SKETCH PLAT

STOWE ADDITION

Re.: S/D 84-99 - Stowe Addition

Final Plat
SUBDIVISION REPORT

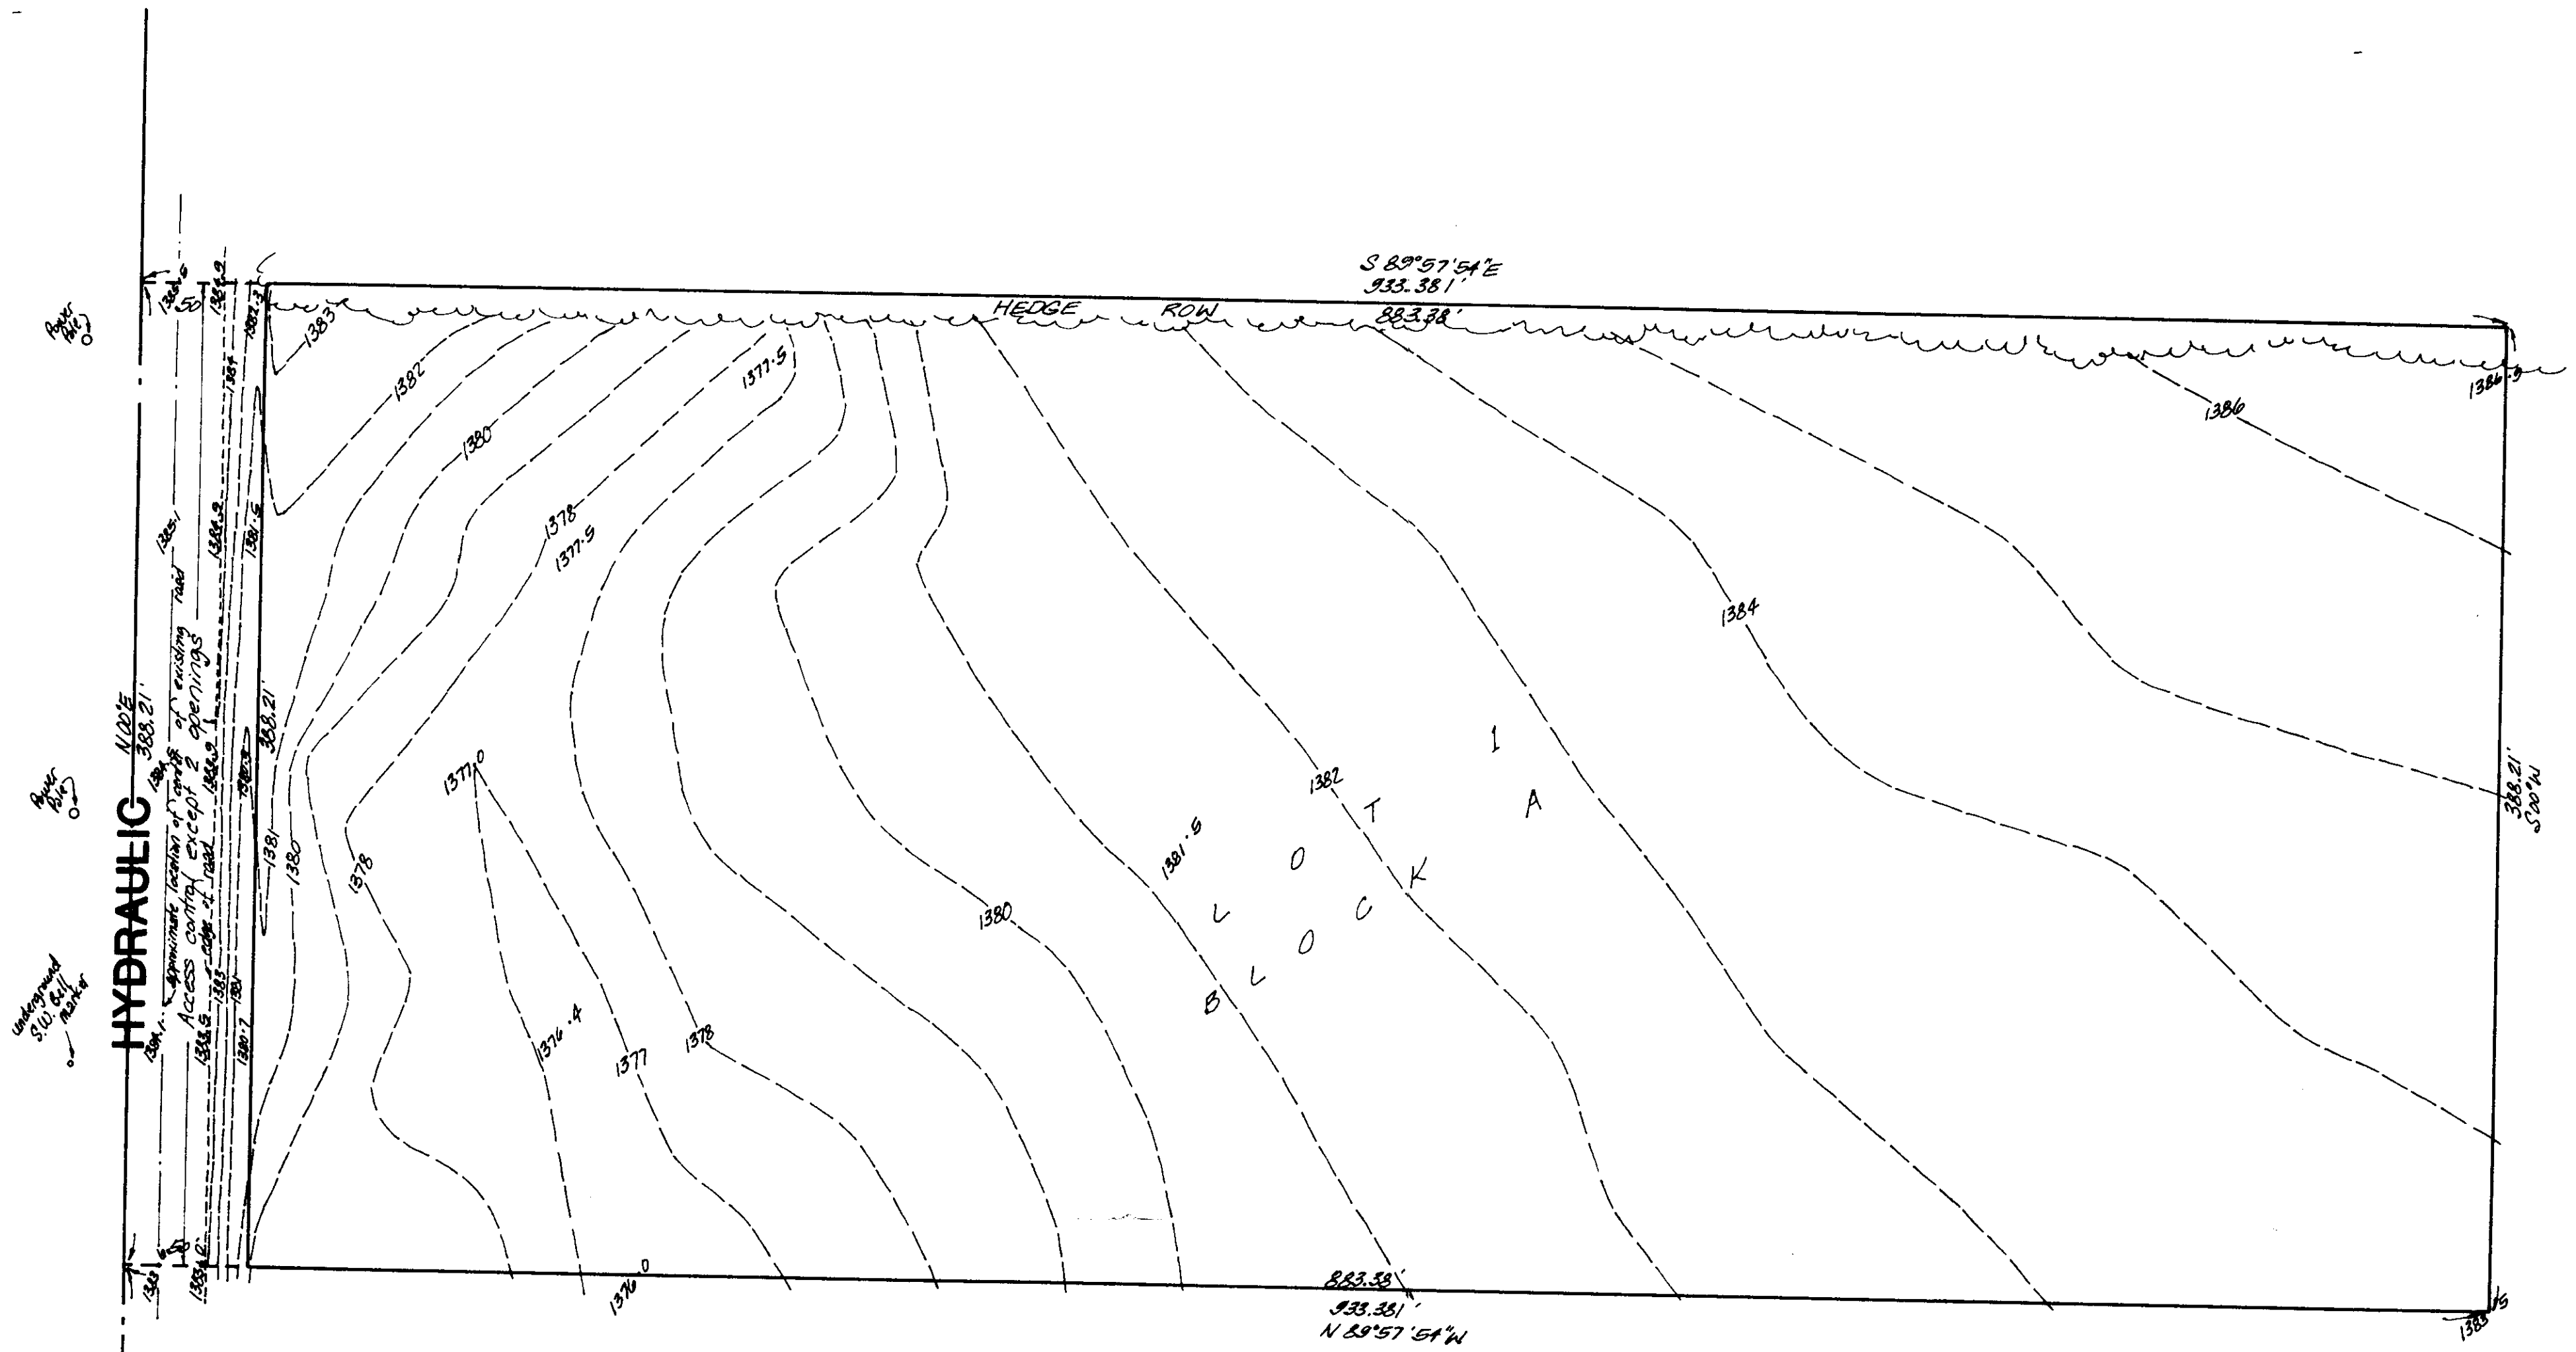
Zone ordinance requires 35' D.S.
 Hydraulic not F.A.S.
 Health Dept. app. reg. H₂O & sewer.

- A. On the final plat tracing, the MAPC signature block shall be corrected to read: JAMES C. WILSON, CHAIRMAN.
- B. The final plat tracing shall indicate "access control except for one opening" to Hydraulic across the west line of the lot.
- C. Since neither public water nor sanitary sewer is available to serve this one-lot plat, the applicant shall contact the Environmental Health Division of the Health Department to find out what tests may be required and what standards are to be met for approval of on-site sewerage and a water well.
- D. The utility company representatives should be prepared to state if any side lot line or rear lot line utility easements are required with the platting of this property.
- E. Recording of the plat within 30 days after approval by the Board of City Commissioners.
